REVIEW OF KEY MINING ISSUES DRAYTON SOUTH COAL PROJECT 2015

Report prepared for Darley Australia and Coolmore Australia

Review of Key Mining Issues Relating To The Drayton South Coal Project EIS 2015

The author was commissioned to review the Drayton South Coal Project EIS May 2015 and the Drayton South Response to Submissions July 2015 and provide comment on any issues that in his opinion were relevant for the attention of Darley Australia and Coolmore Australia.

Figure 1. Mine Actual Performance vs 2007 EA Schedule

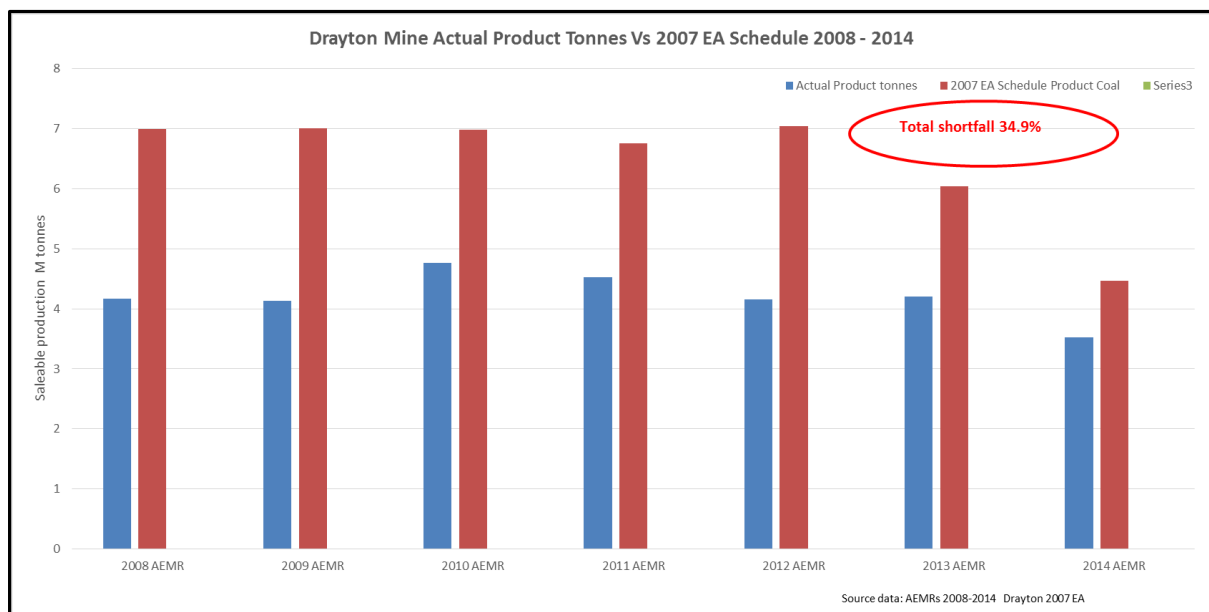
Figure 1 shows that for each year from 2008 to 2014 the actual saleable production was significantly less than the schedule provided in the 2007 EA. The total shortfall in that period was 15.8 million product tonnes or 34.9%. This shortfall occurred during a period of peak and sustained high coal prices when mine operators had strong economic incentive to maximise production levels (see figure 2 below).

It is recommended that the economic analysis for the project include a sensitivity analysis for a range of production level outcomes similar to the previous shortfall (35%) identified here. It is understood the current range used for sensitivity analysis is 20%.

Figure 3. 2015 EIS Production Schedule Summary and Production Profile

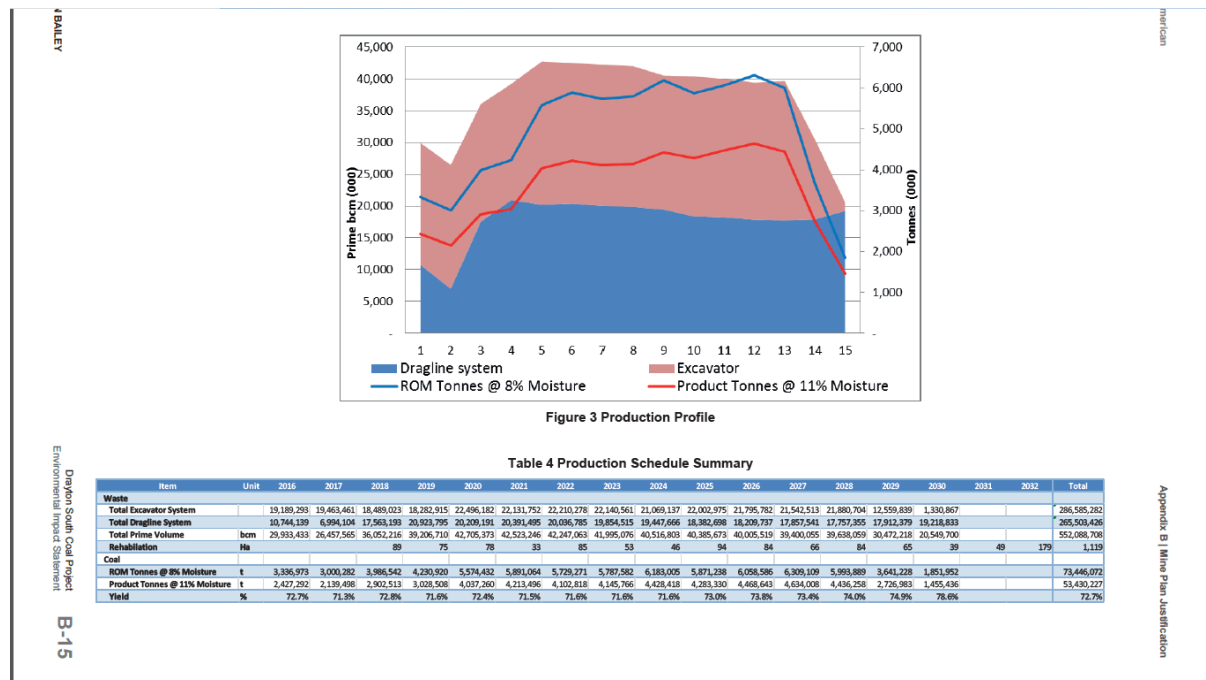
The annual waste movement quantities included in this schedule are labelled as “Total Dragline System” and the “Total Excavator System”. It appears that the cast blasting and dozer push quantities have been aggregated with the dragline prime quantities. This may also be the case with excavator quantities being supplemented with smaller quantities by loaders or dozer push.

This aggregated data makes it difficult to compare the assumed annual production by fleet type against industry benchmark information. In order to accurately assess the actual achievability of the fleet assumptions contained in the EIS, more information and greater transparency as to the data and methods used is required.

It appears that 1.4 million ROM tonnes (equivalent to the Drayton mine ROM tonnage) are missing from the Drayton South Project Production schedule, yet the associated waste volume has been included. This appears to be an inconsistent and incorrect presentation of key information.

The life of mine total ROM coal shown in the Production Schedule Summary is 73.446 M ROM tonnes.¹ This is reproduced as Figure 3 above. The dragline waste volumes shown in Year 1 and Year 2 of the Schedule and Profile must be from Drayton Mine based on the information provided in the EIS that the dragline does not relocate to the new Drayton South area (Whynot Pit) until Year 3.

Figure 4. Comparison of waste fleet annual production 2012 EA vs 2015 EIS

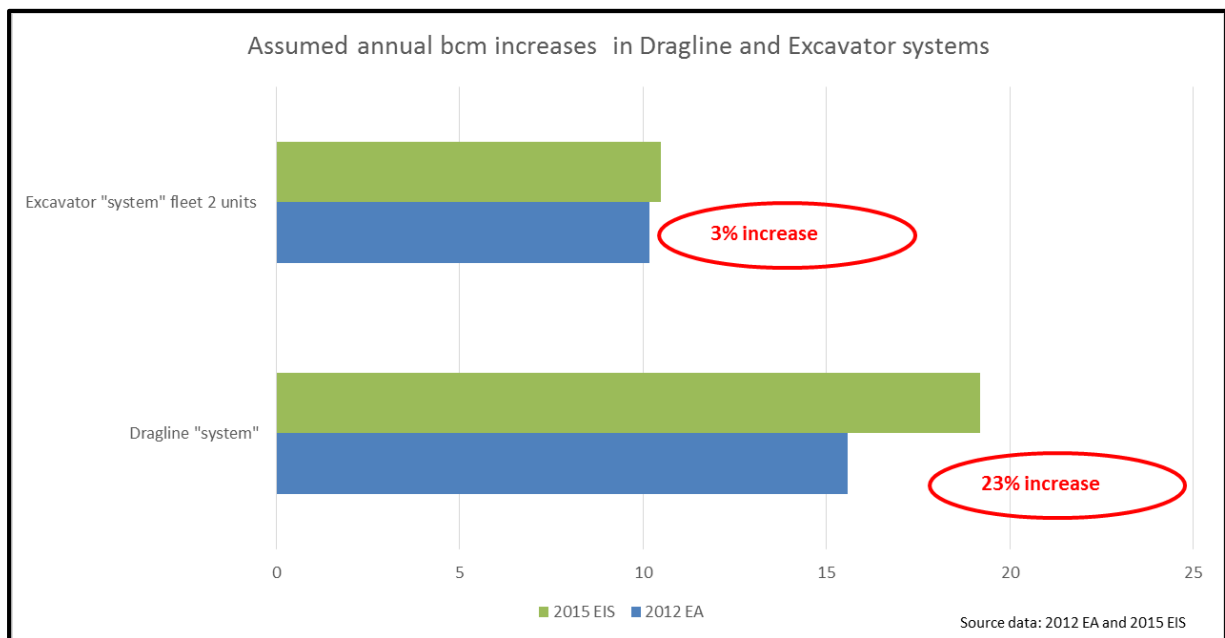
An increase of 3% in annual output assumptions for the excavator “system” appears reasonable.

The “dragline system” shows an increase of output assumptions of 23%. This is **remarkable and requires further explanation before it could be accepted at face value.**

Additionally, this increase in output warrants scrutiny in light of statements made in the March 2014 Consequential EIA For Retracted Mine Plan. In that EIA it was stated that the loss of Redbank Pit would *negatively* impact dragline productivity for the project. In the current Project Proposal mine plan the Redbank Pit has now been largely removed.

Figure 4 above shows that the “excavator system” has an average of 10.49 million prime bcms scheduled per year per machine for the first 13 years of mine life. It is unclear how many bcms per year are scheduled to other equipment within the “excavator system”, like loaders or dozers. If the 500 tonne class excavators are scheduled to be moving the major portion of this waste, then they will need to achieve consistently high availability, utilisation of the available time and production rates per hour. Any reduction in this performance would result in a shortfall of production from these excavators.

Figure 5 ROM strip ratio for Hunter Valley Mines 2013-2014

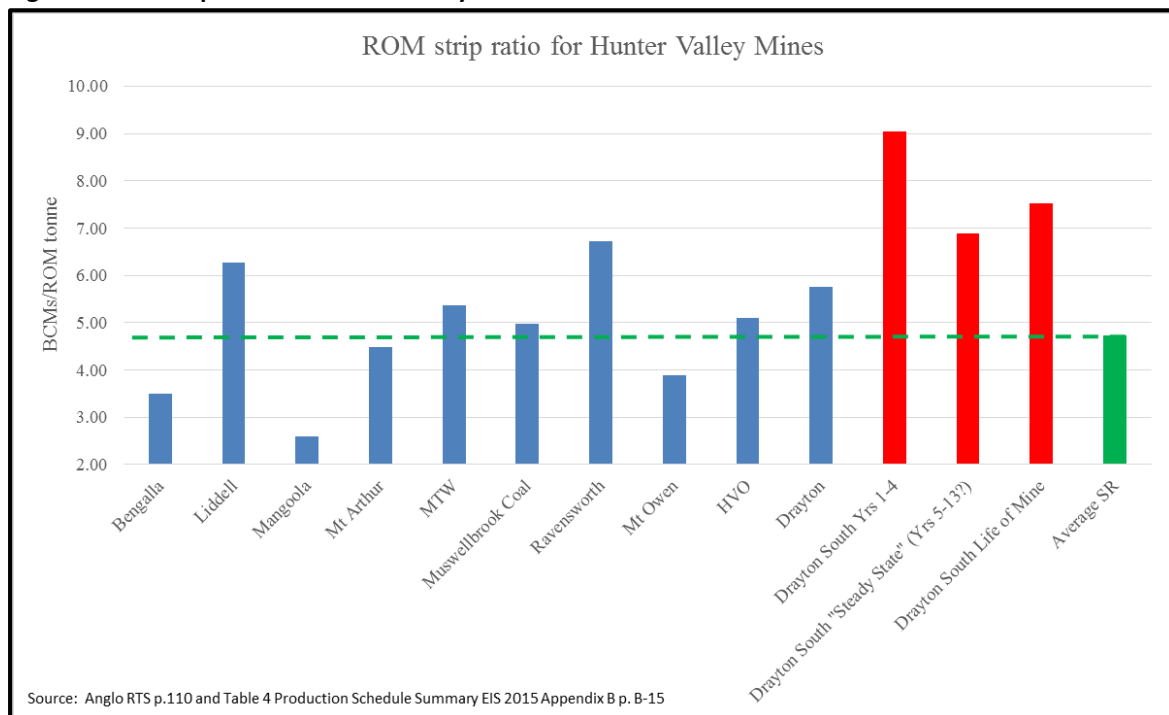
The EIS expresses the strip ratio as the quantity of bank cubic metres that need to be mined per tonne of ROM coal. Figure 5 below shows the ROM Strip Ratio for Hunter Valley Mines. From this table the following information is clear:

- Years 1-4 of the Project Mine Plan have an average SR of 9.04. This is 92% higher than the average SR for all mines shown of 4.72.
- The life of project average SR is 7.53. This is 60% higher than the SR average across all mines shown

This demonstrates that Drayton South faces a significant cost challenge when compared to its industry peers as a result of the high Strip Ratio of the mine. This is unavoidable because it is a feature of the resource and will be present for every ROM tonne produced in this plan.
